SYDNEY WESTERN CITY PLANNING PANEL
COUNCIL ASSESSMENT REPORT

Panel Reference	2017SSW056
DA Number	DA-757/2017
Local Government Area	Liverpool City Council
Proposed Development	Construction of a seniors housing development comprising of 8 x two-three storey buildings containing a total of 145 two-bedroom Independent Living Units, including the construction of a shared internal vehicle and pedestrian driveway from Edmondson Avenue; car parking, landscaping works and extension/augmentation of services and utilities over seven (7) stages.
Street Address	222 Edmondson Avenue, Austral (Lot 1 DP 1146302) and 130 Tenth Avenue, Austral (Lot 2 DP 1146302)
Applicant	TSA Management
Owner	RSL Lifecare Limited
Date of DA Lodgement	22 September 2017
Number of Submissions	Two (2) submissions
Regional Development Criteria (Schedule 4A of the Act)	The development has a CIV of \$61,001,934
List of All Relevant S4.15(1)(a) Matters	<ol style="list-style-type: none"> 1. <i>List all of the relevant environmental planning instruments: Section 4.15 (1)(a)(i)</i> <ul style="list-style-type: none"> • State Environmental Planning Policy No.65 – Design Quality of Residential Apartment Development. • State Env

Figure 17: Amended Landscape Concept Plan

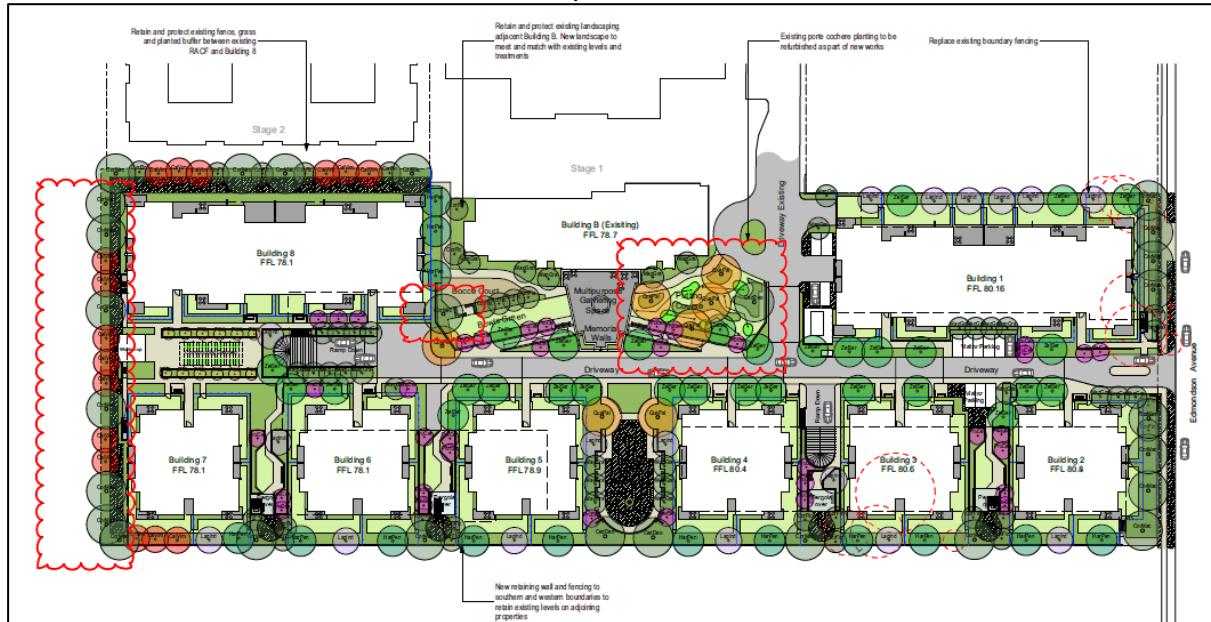
Comment 1: The Panel recommends that the applicant gives further consideration for the provision of greater canopy trees within the development site. The communal open space in the centre of the proposal is likely to be hot and should be afforded with large canopy trees for shade, amenity and environmental reasons.

Applicant's response: *The provision of greater canopy trees, as recommended by the DEP, is supported by the applicant. Several canopy trees have been added to the revised landscape scheme for the site within the central communal open space and along the western boundary. This will provide amenity in the form of shade for residents and natural screening from the future proposed residential development to the west.*

Below is an extract of the amended landscape scheme:

Figure 19: Revised scheme for Building 7

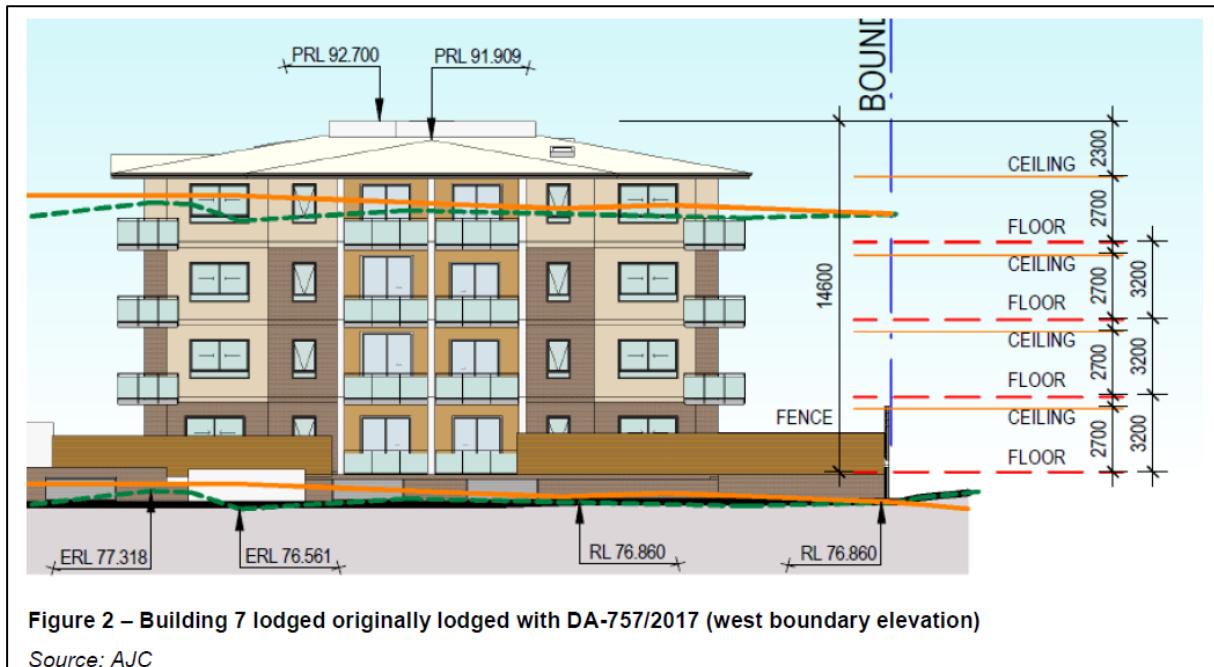
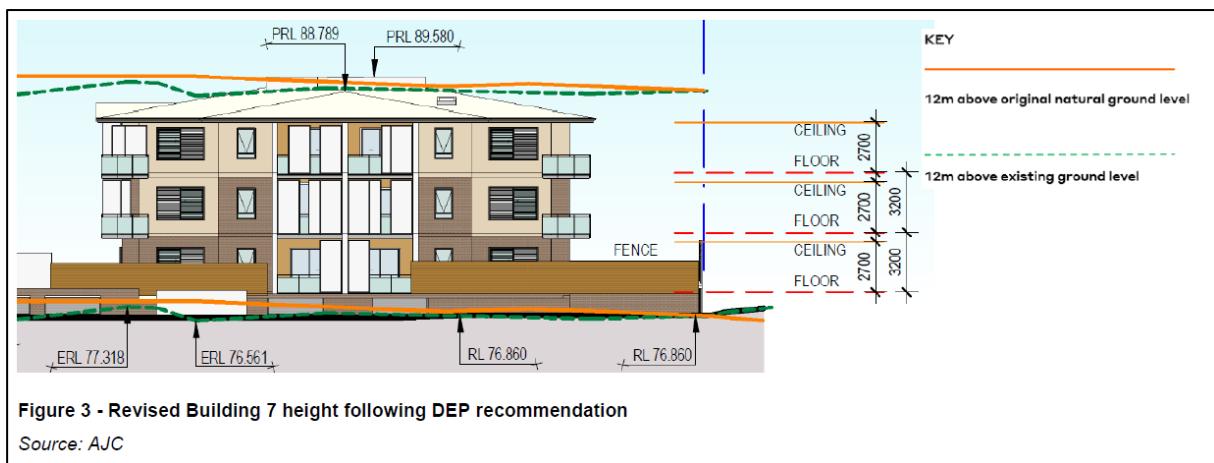
- Potential interface impacts on the site to the west where a new subdivision development is proposed.

Applicant's response: The height of building 7 will be reduced from four storeys to three storeys (14.53m to 11.42m in line with the recommendations of the Sydney Western City Planning Panel. This will be consistent with the western portion of Building 8 and ensure a consistent three storey height along the western boundary of the site (refer to figures 18 and 19 below).

Council's response: It is noted that there are potential interface issues between two different residential land uses being residential development at 144 Tenth Avenue Austral and seniors housing. There are privacy implications associated with the proposed development onto the residential development approved under DA-219/2017
